Product change New marking for EPCOS Y1 series B81123 with ENEC15 certification

Product / Process Change Notification

1. ID No.: 600257		2. Date of announcement: March 10, 2017	
3. Product / product group: Y1 EMI suppression capacitors	Old ordering code: B81123	New ordering code: No change	Customer part number:

Previous

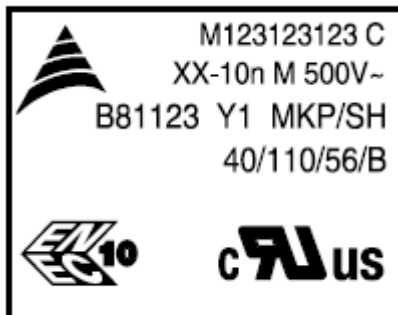
The marking of the B81123 EPCOS EMI suppression capacitors (Y1) will be changed following its certification to ENEC15 for 500 V AC in addition to the UL60384-14 approval for 500 V AC.
